SECCRA Community Landfill

Earthwork CELL 8a

ADDENDUM No. 1

April 4, 2022

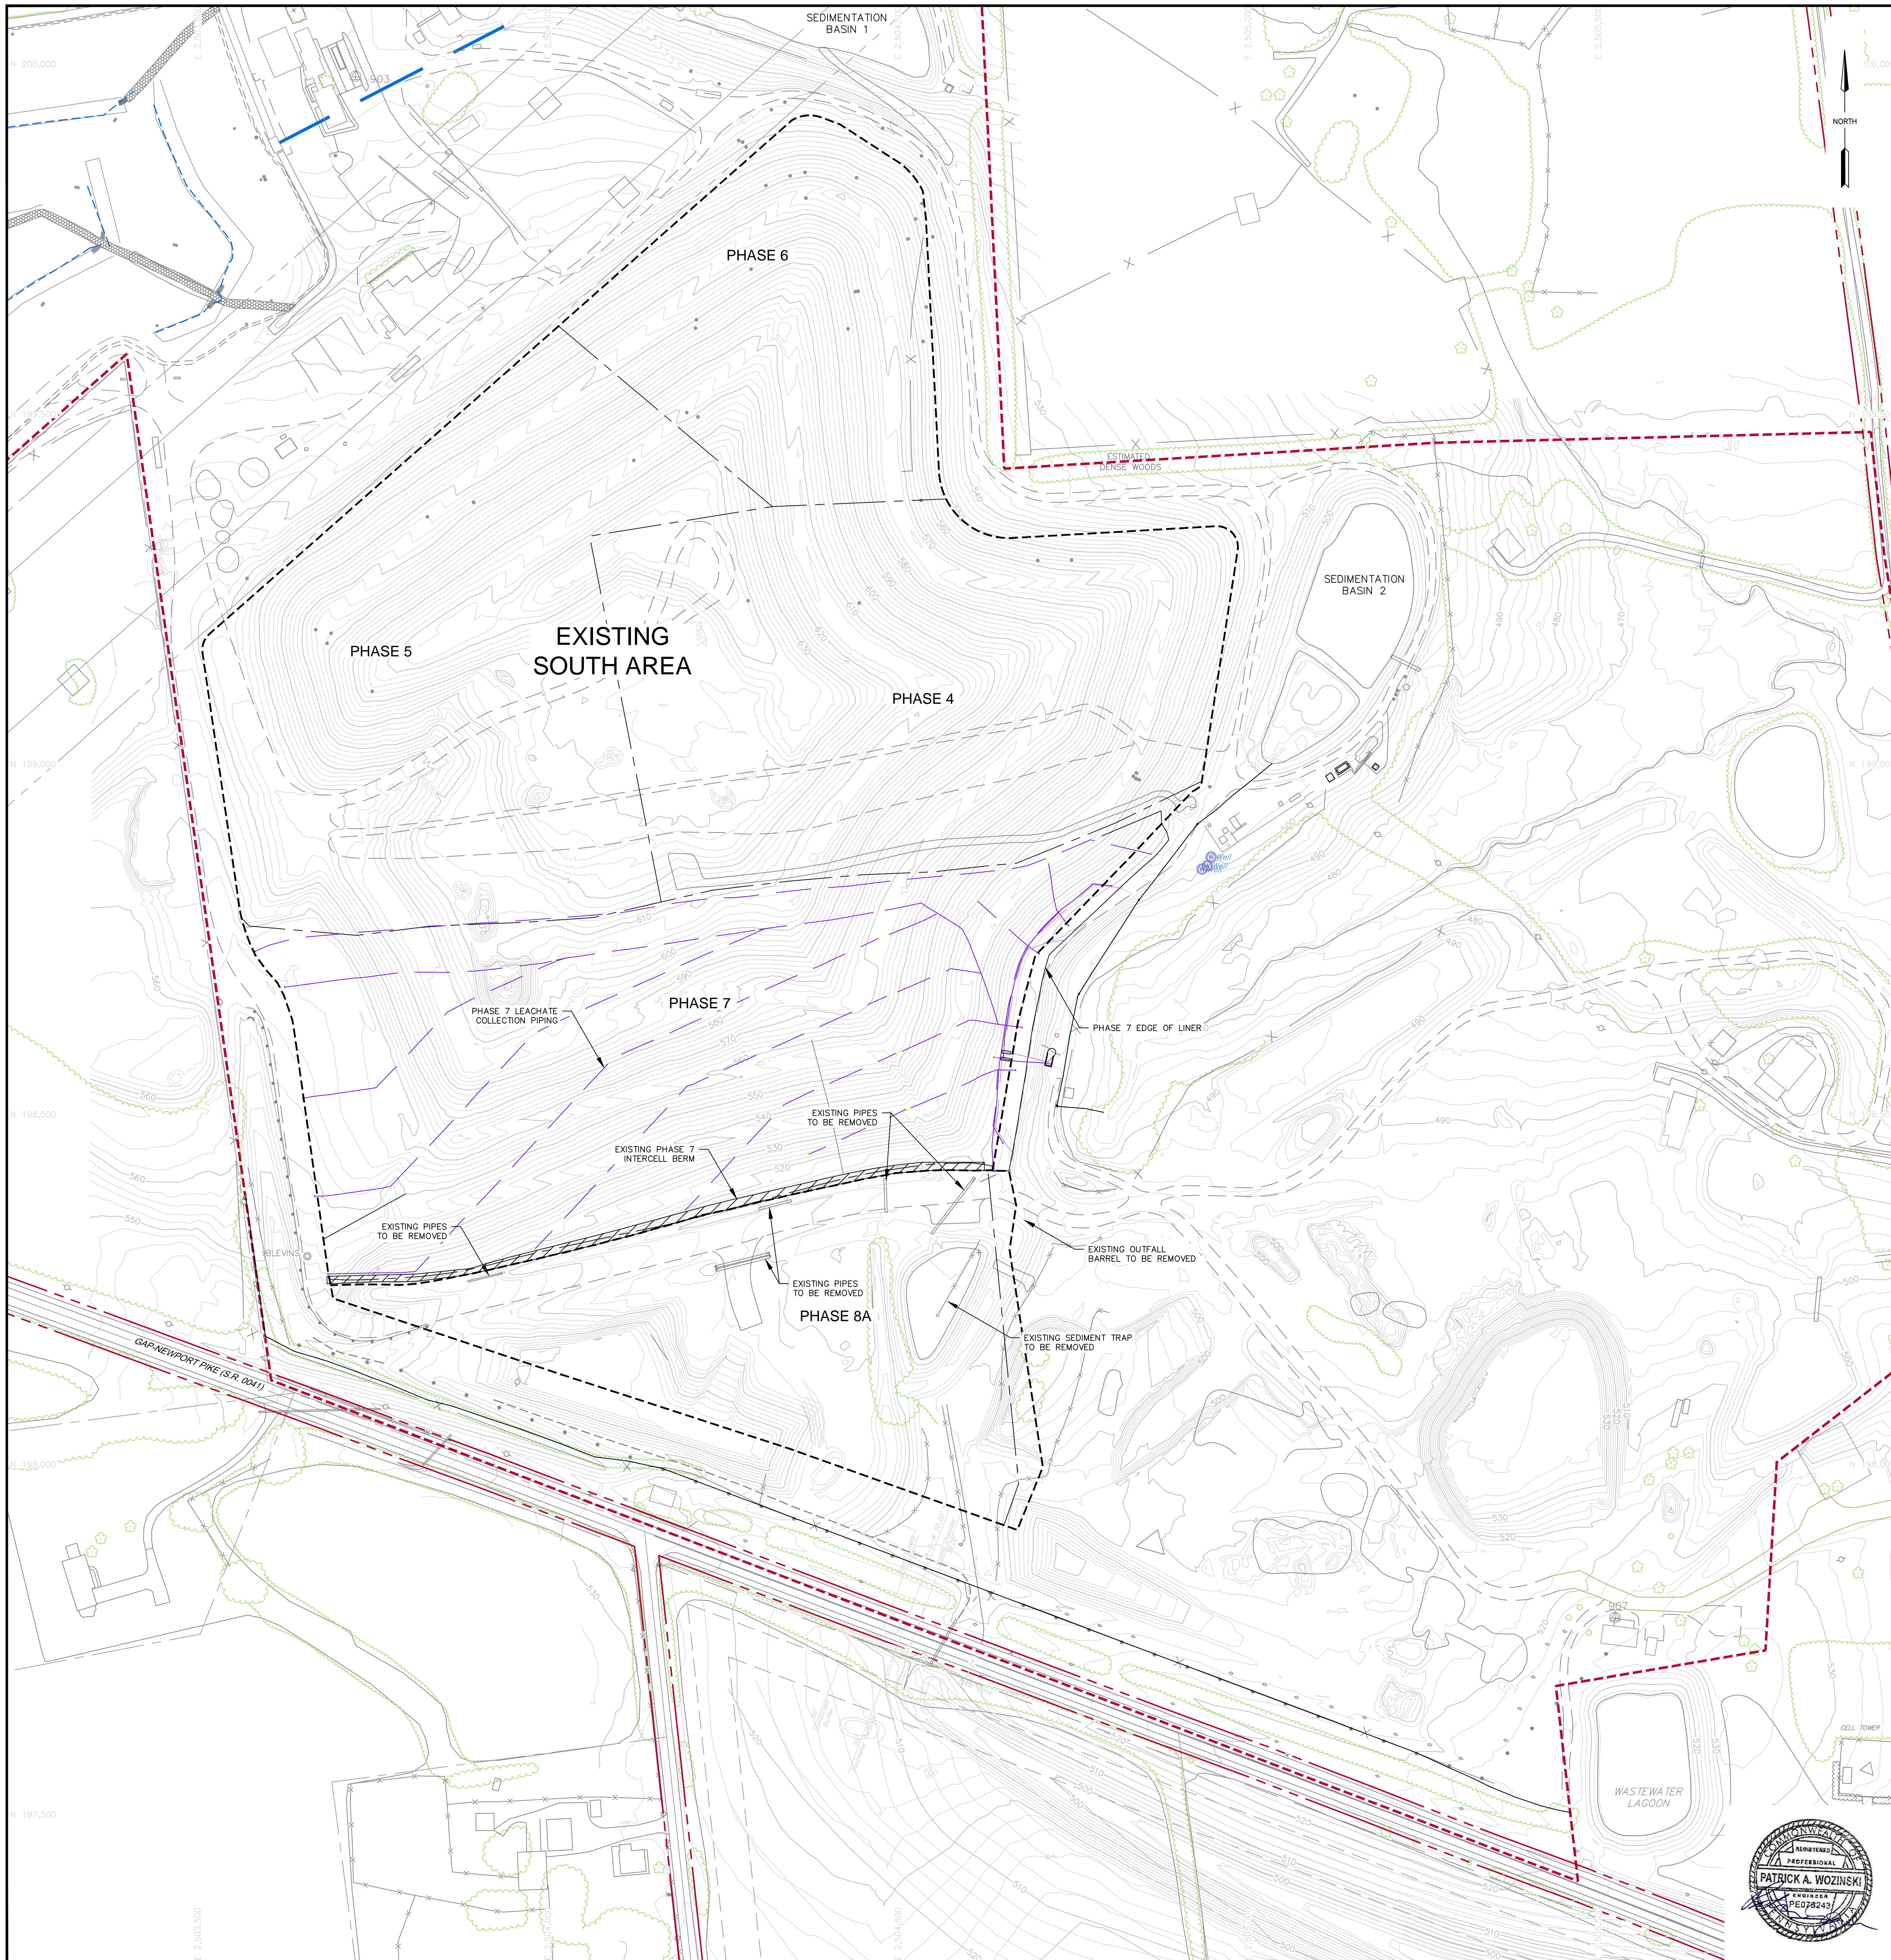
<table border="1"> <thead> <tr> <th colspan="2">REVISIONS</th> </tr> </thead> <tbody> <tr> <td>4/04/2022</td> <td>MODIFIED EXISTING PIPE ALIGNMENT</td> </tr> <tr> <td> </td> <td> </td> </tr> <tr> <td> </td> <td> </td> </tr> <tr> <td> </td> <td> </td> </tr> </tbody> </table>	REVISIONS		4/04/2022	MODIFIED EXISTING PIPE ALIGNMENT							<table border="1"> <tr> <td>DATE:</td> <td>7/27/2021</td> </tr> <tr> <td>DRAWN BY:</td> <td>RWS</td> </tr> <tr> <td>CHECKED:</td> <td>PW</td> </tr> <tr> <td>BAI DRAWING NO:</td> <td>ROMAN-171E001A R1</td> </tr> <tr> <td>SHEET NO.</td> <td>1 OF 6</td> </tr> </table>	DATE:	7/27/2021	DRAWN BY:	RWS	CHECKED:	PW	BAI DRAWING NO:	ROMAN-171E001A R1	SHEET NO.	1 OF 6
	REVISIONS																					
4/04/2022	MODIFIED EXISTING PIPE ALIGNMENT																					
DATE:	7/27/2021																					
DRAWN BY:	RWS																					
CHECKED:	PW																					
BAI DRAWING NO:	ROMAN-171E001A R1

DRAWN BY: **RWS**
CHECKED: **PW**
BAI DRAWING NO: **ROMAN-171E001F R1**
SHEET NO: **6 OF 6**

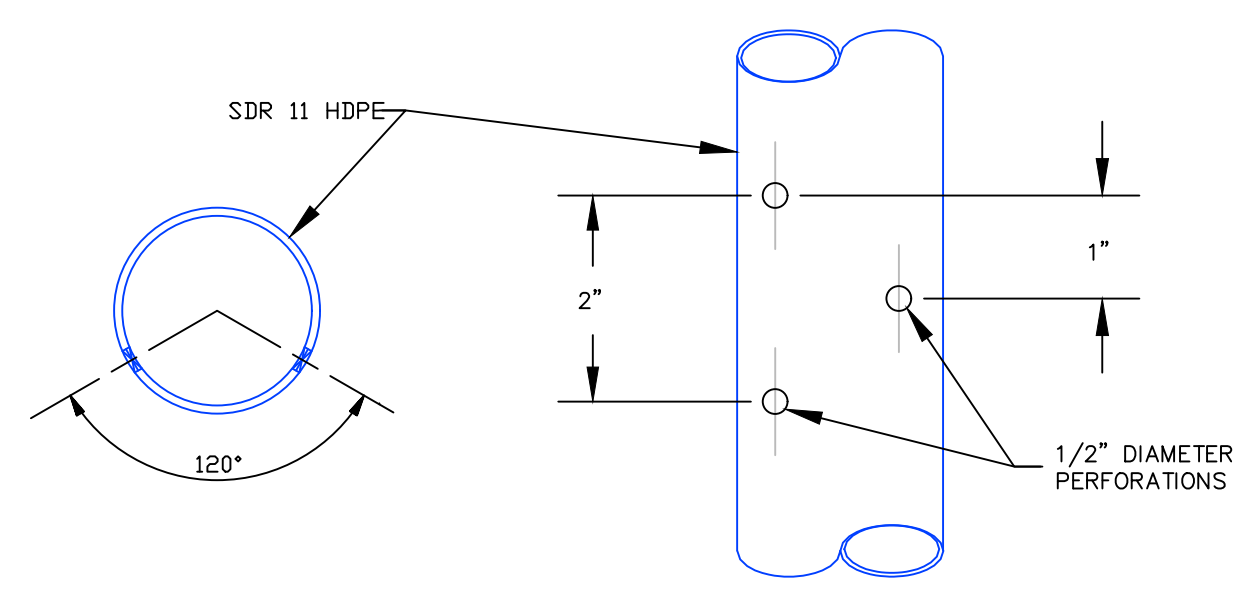
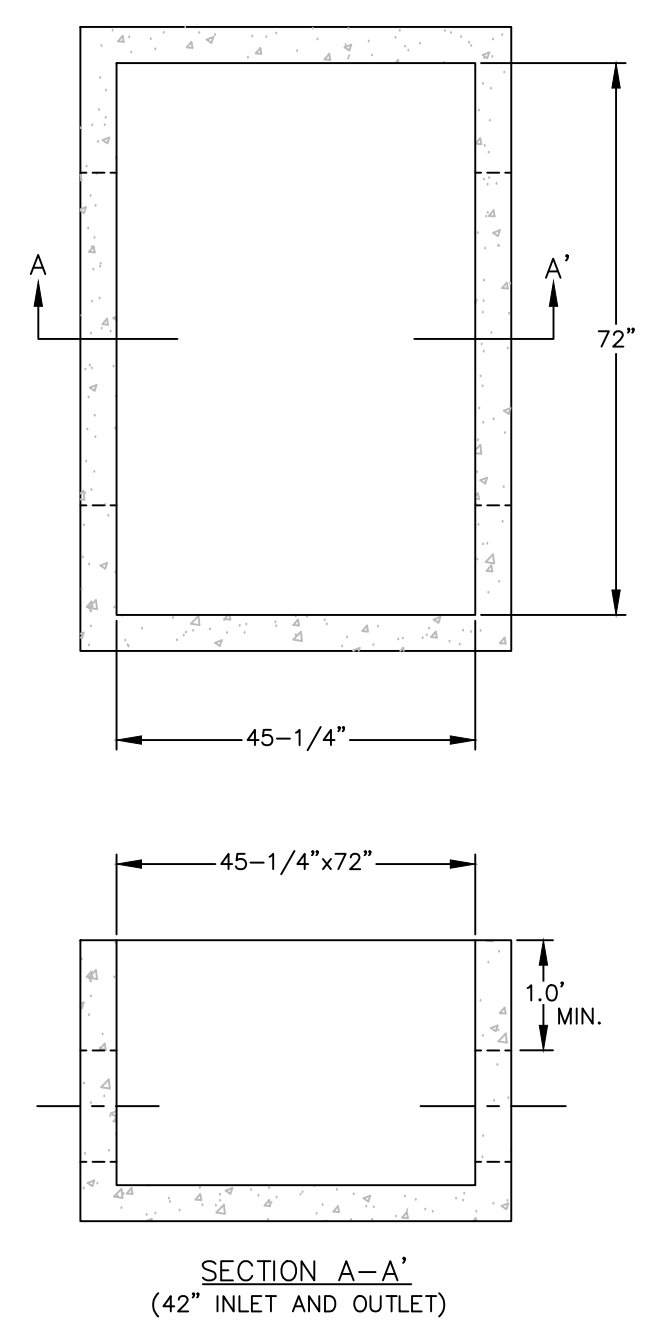
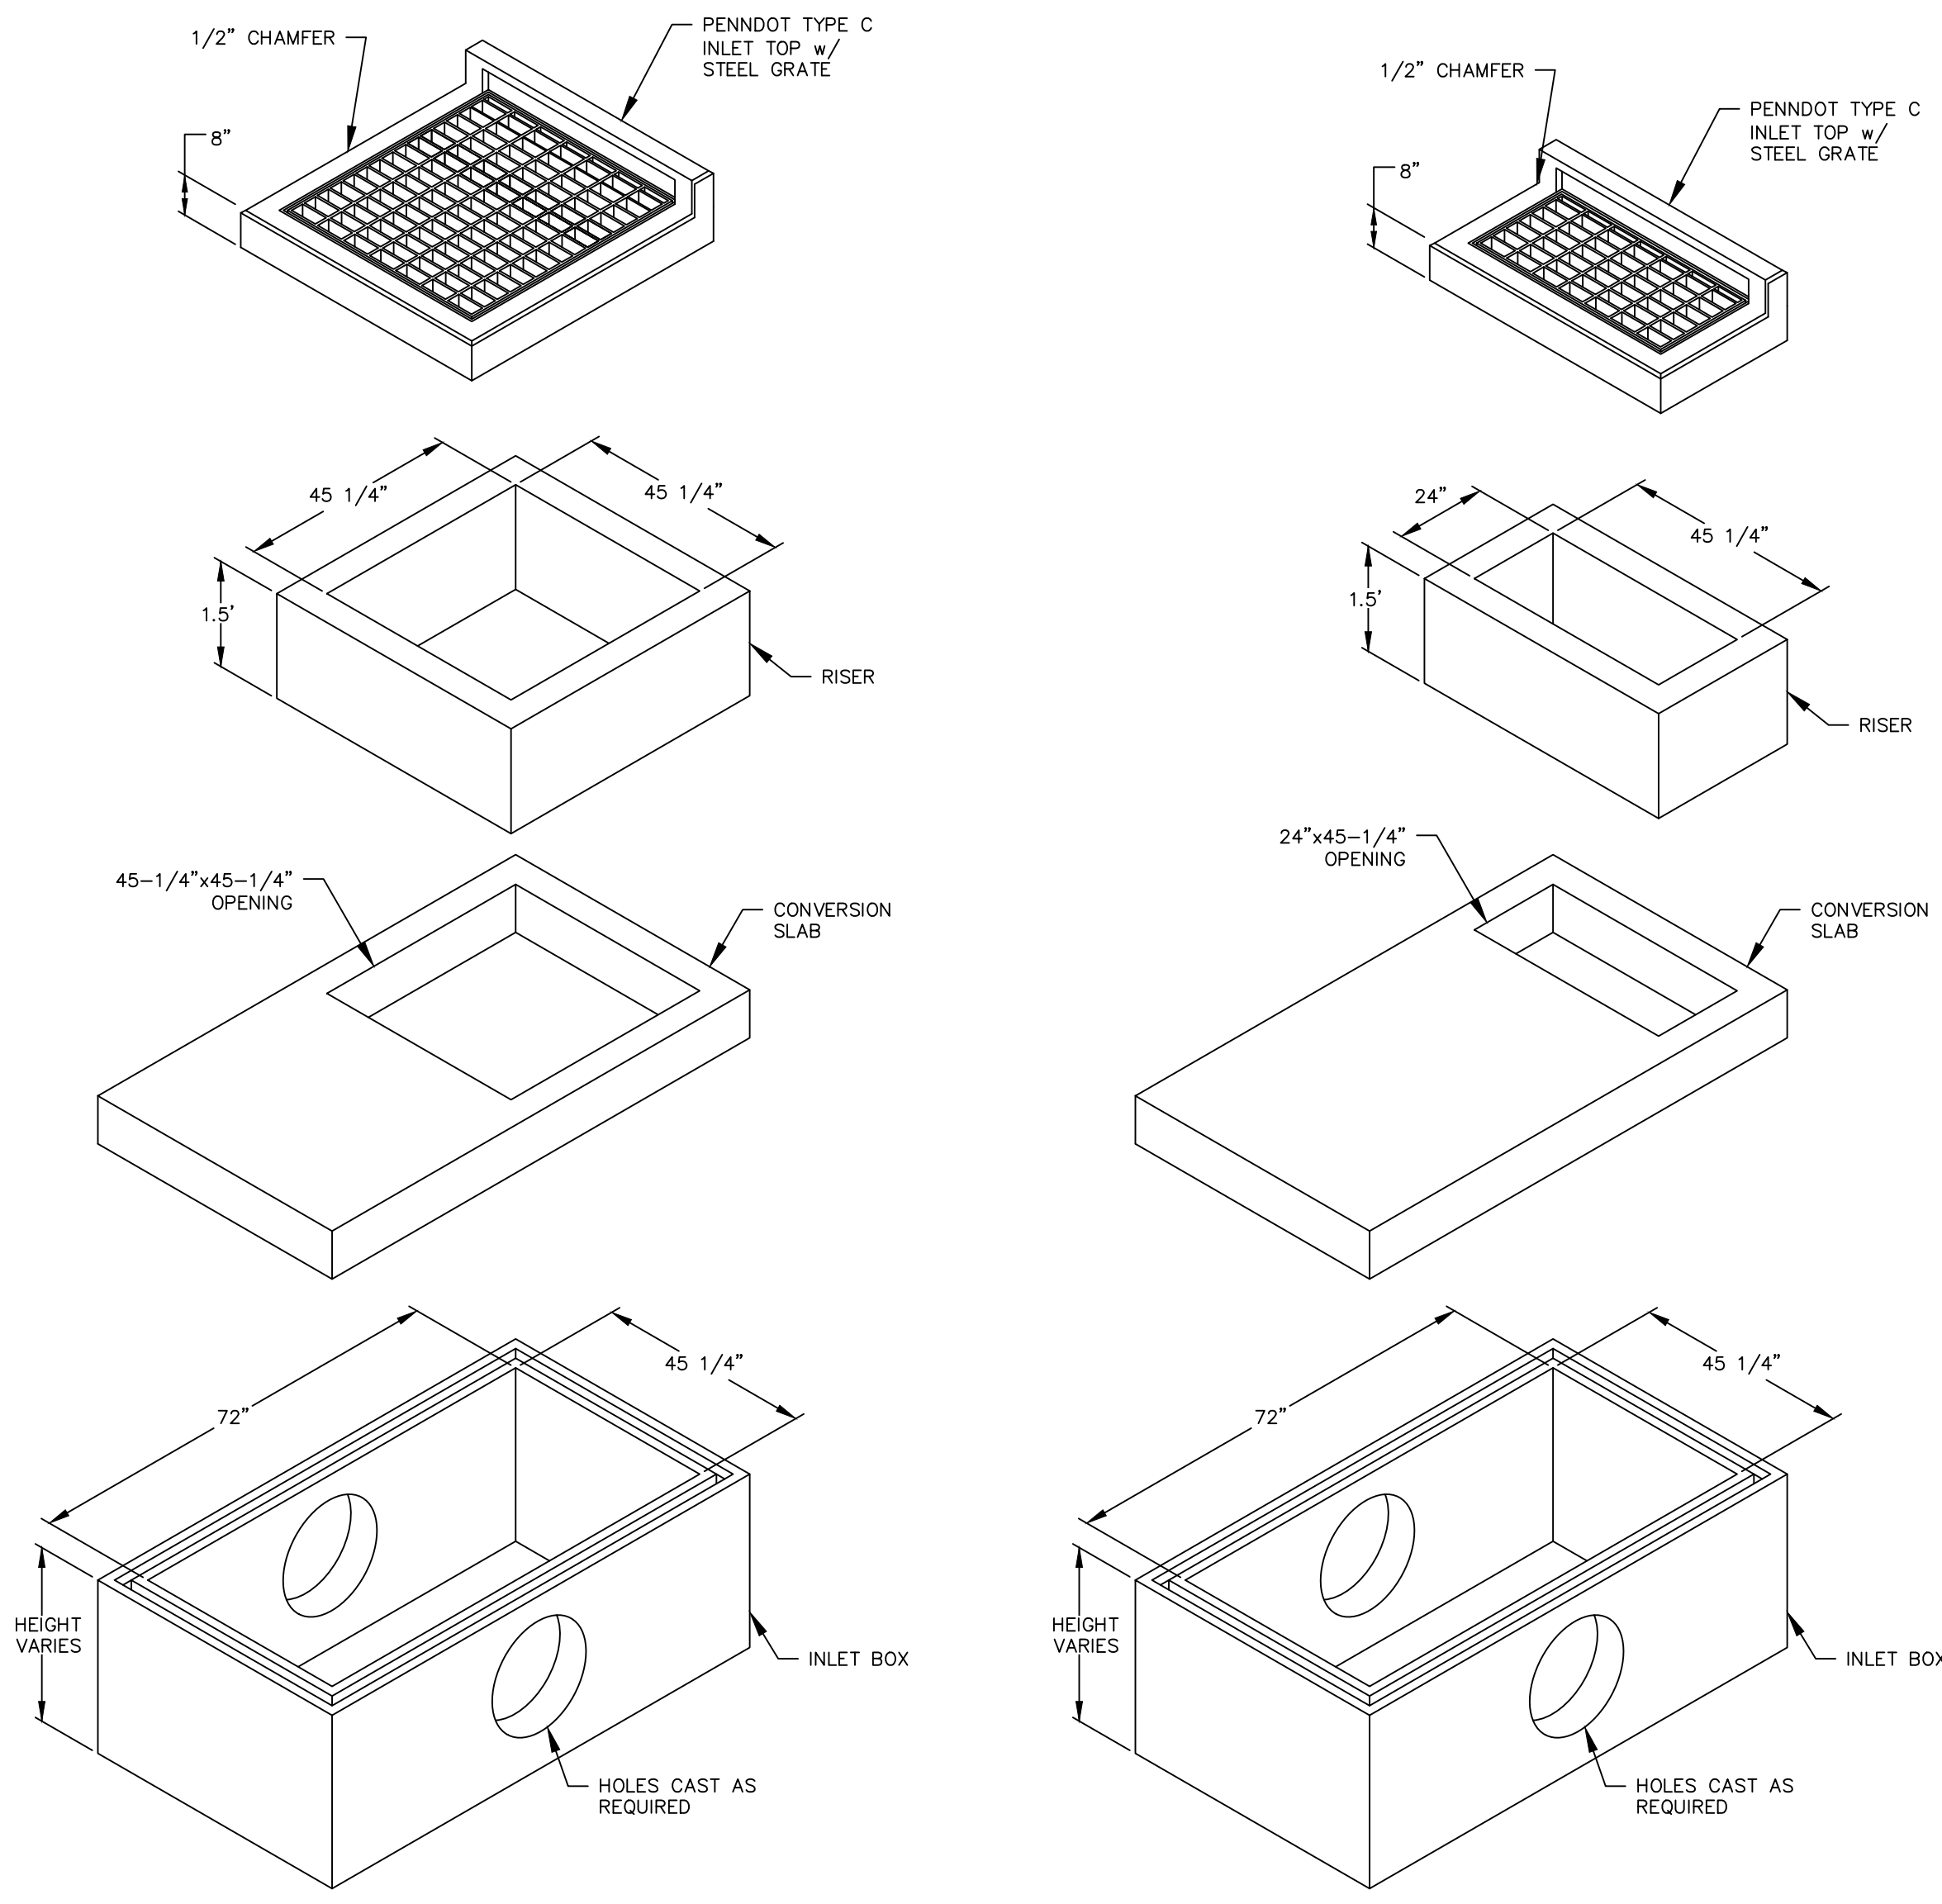
REVISIONS		DATE:
4/04/2022	MODIFIED DETAIL 1/6	2/07/2022
